AMENDMENT OF SOLICITATION/MODIFICATION OF CONTRACT				1. CONTRACT ID CODE	PAGE OF PAGES	
				J	1	16
2. AMENDMENT/MODIFICATION NO. 0001		3. EFFECTIVE DATE 06-Jul-2007	4. REQUISITION/PURCHASE REQ. NO.		5. PROJECT NO.(If applicable)

14. DESCRIPTION OF AMENDMENT/MODIFICATION (Organized by UCF section headings, including solicitation/contract subject matter where feasible.)  The above numbered solicitation for Atchafalaya Basin, Gulf Intracoastal Waterway (GIWW) and Miscellaneous Projects, Cutterhead Dredge Rental No. 3-2006, St. Martin and St. Mary Parishes, Louisiana, is amended as shown on the attached pages.  BID OPENING DATE: A BID OPENING DATE OF 11 JULY 2007, 11:00 AM LOCAL TIME AT PLACE OF BID OPENING, IS HEREBY ESTABLISHED.						
Except as provided herein, all terms and conditions of the document referenced in Item 9A or 10A, as heretofore changed, remains unchanged and in full force and effect.						
15A. NAME AND TITLE OF SIGNER (Type or print)			16A. NAME AND TITLE OF CONTRACTING OFFICER (Type or print)			
			TEL:		EMAIL:	
15B. CONTRACTOR/OFFEROR  _____ (Signature of person authorized to sign)		15C. DATE SIGNED	16B. UNITED STATES OF AMERICA  BY _____ (Signature of Contracti

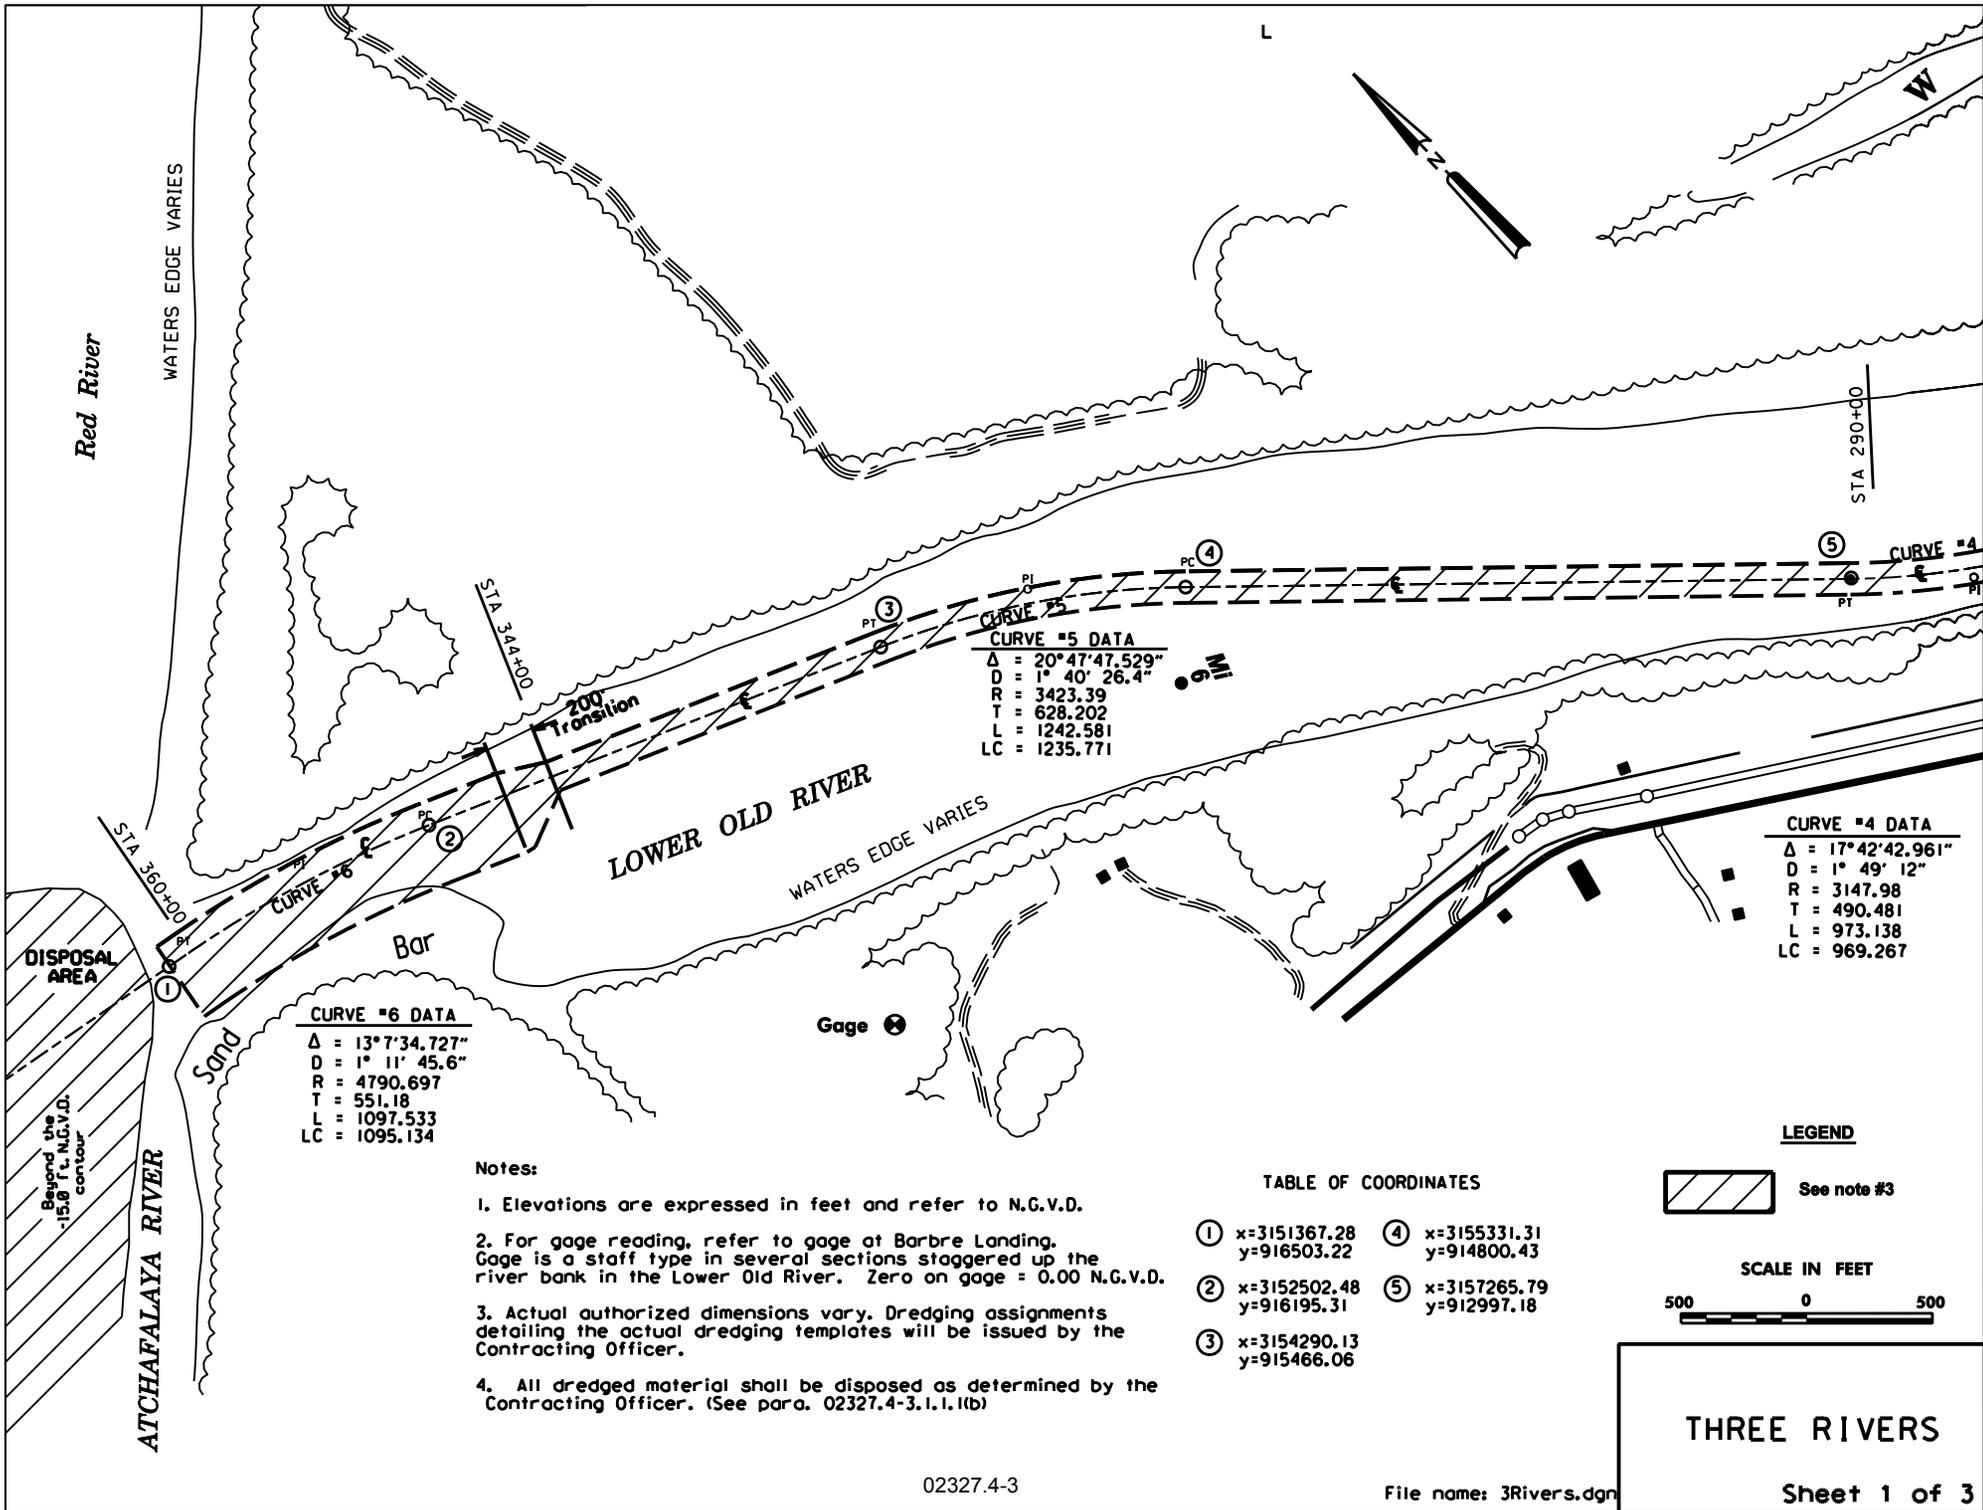
b. Delete pages 02327.4-3 and 02327.4-4 and replace with the attached pages 02327.4-3, 02327.4-4 and 02327.4-5.

Sheet 1 of 3

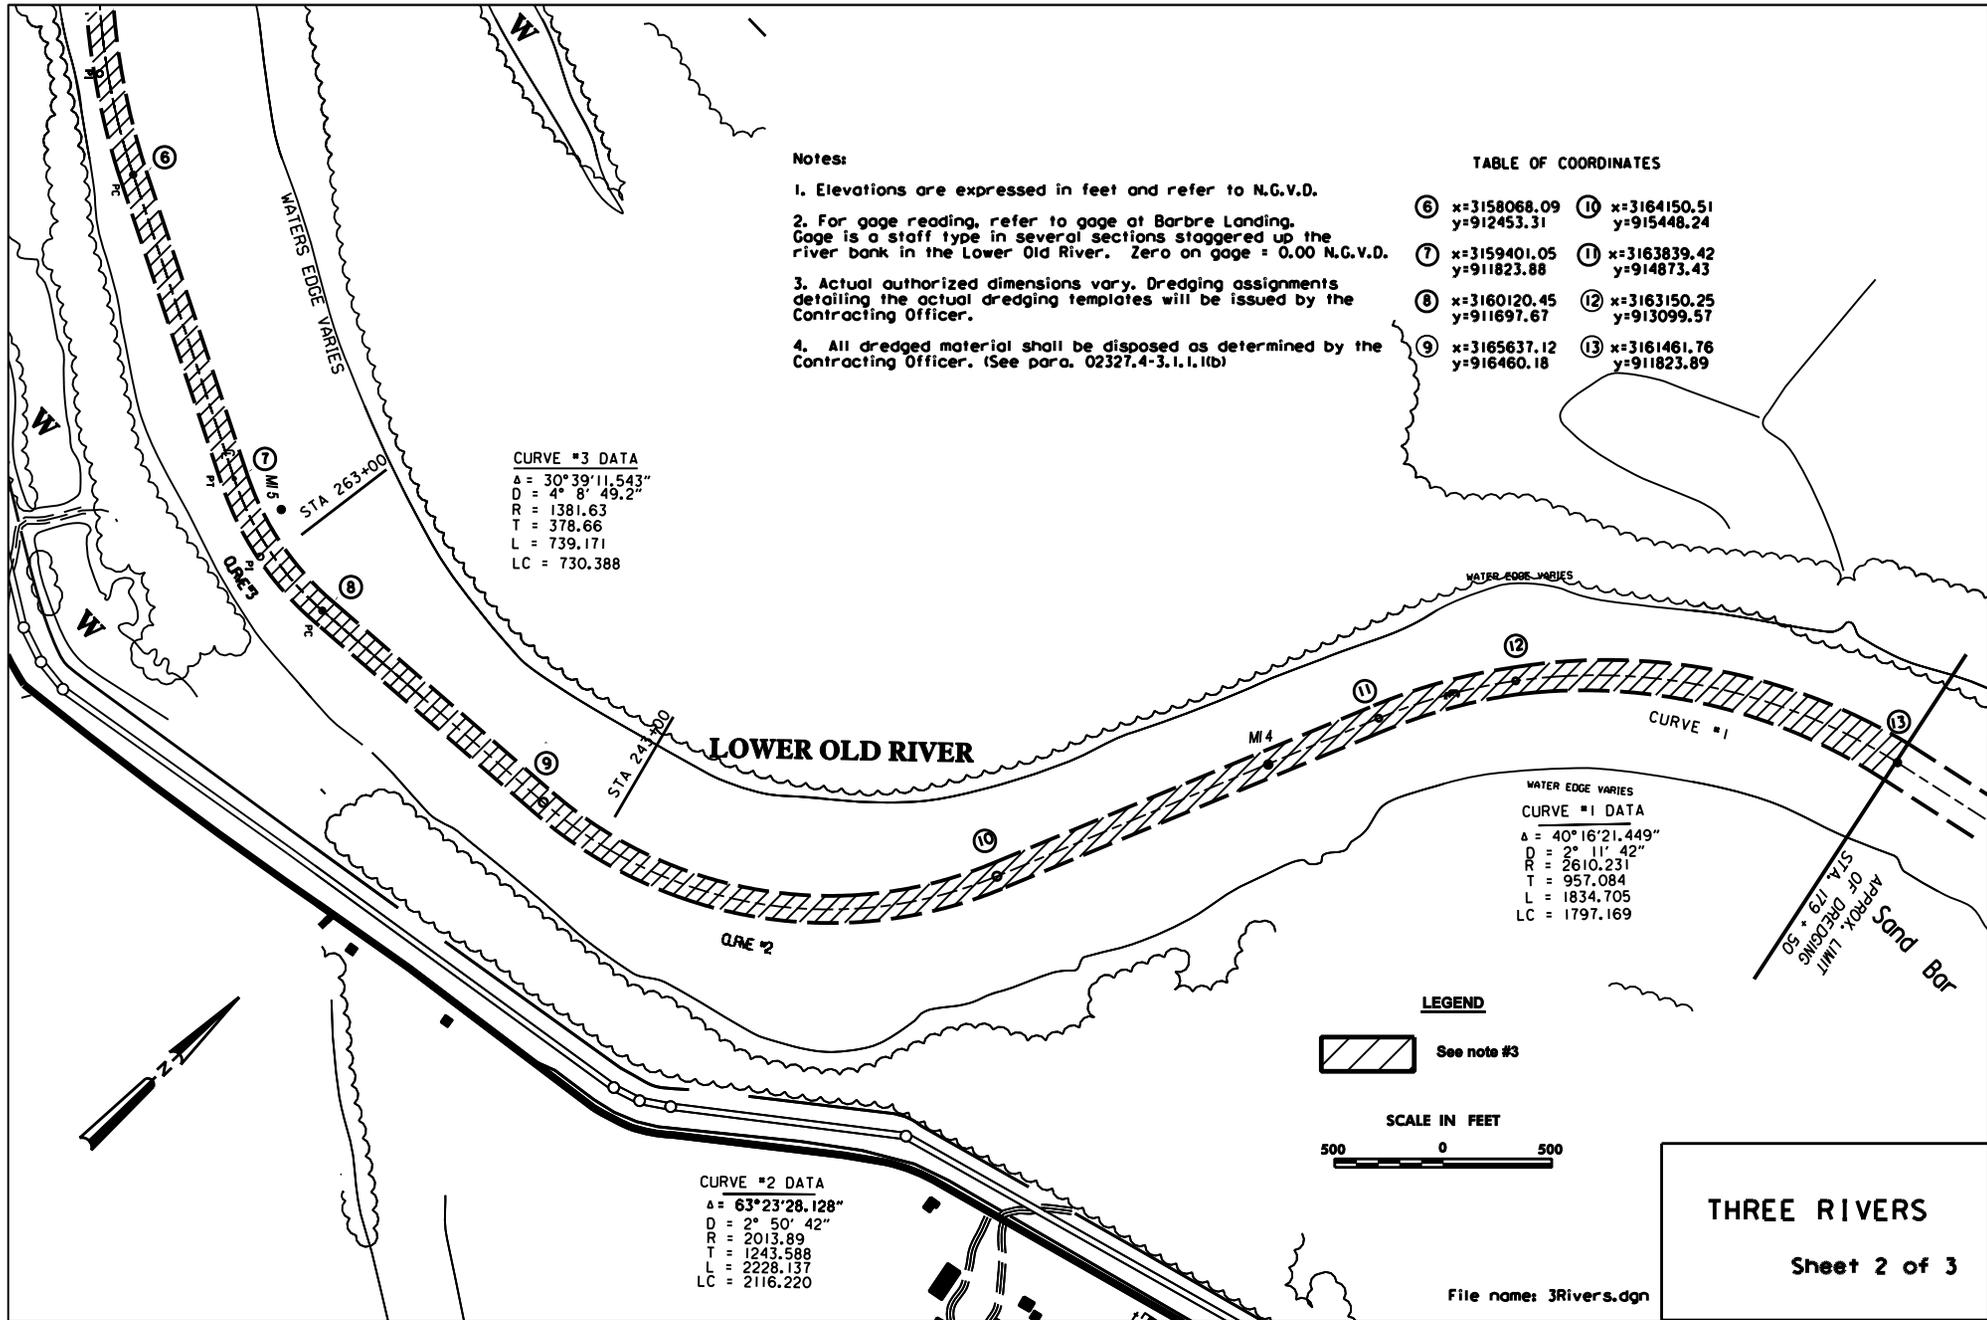
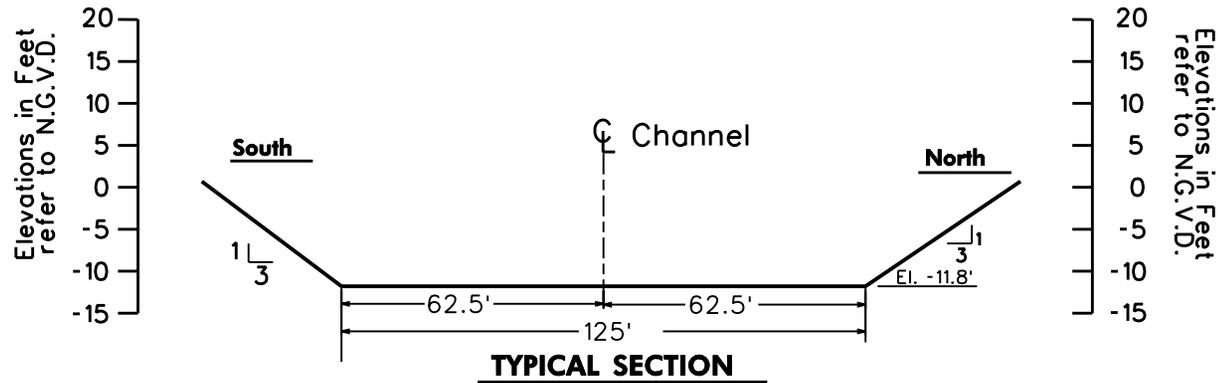
9. Section 02327.4
  - a. Page 02327.4-1, paragraph 3.1.1.1(b). Replace paragraph with the following:

“b. At the direction of the Contracting Officer or his/her authorized representative dredged material may be placed in either of the disposal areas described below.

(1) Dredged material may be placed along the south bank of the Atchafalaya River beyond the -15 feet NGVD contour. The discharge pipe will be at least 500 feet from the revetted shoreline and surface disposal techniques will be used to disperse the sediments midstream. No disposal shall be higher than elevation -15 feet NGVD.

(2) Dredged material may be discharged in open water between navigation channel centerline stations beginning at 243+00(+/-) proceeding to 263+00(+/-). No disposal shall be placed higher than El. -12 feet NGVD.”
